FIELD SERVICE BULLETIN

FSB Number: BJCCFSB2004-135
Author: Fang Hong
Date: June 7, 2004
Total No. Of Pages: 3
Subject: **V878 (TCH) Camera Display 'X'**
Model Affected: **V878 (TCH) GSM/DCS/PCS**
Level of Repair: 3

Error Photo

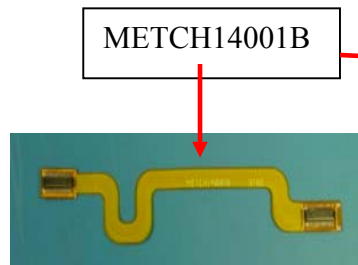
An issue was identified during analysis of returned V878 units. Some handsets have been returned with the customer complaint of "Camera display 'X'." The symptom is that the LCD display is 'X' after taking a photo.

This issue is due to some errors of the falling time of LCDCS signal. CPU read the error data of photo. Corrective action is to add a 33pF capacitor between LCDCS and GND on main PCB. The new PCB is named HW7. The HW7 is being tested by Motorola.

For HW5 and HW6 unit, the solution is to replace a new FPC, P/N is METCH14001B.

If the returned unit is complained of 'Camera display X', Please Verify the symptom of issue. Check the symptom after replacing a new FPC.

If the symptom disappears, the handset is ok.

If the symptom exists, replace a main board.
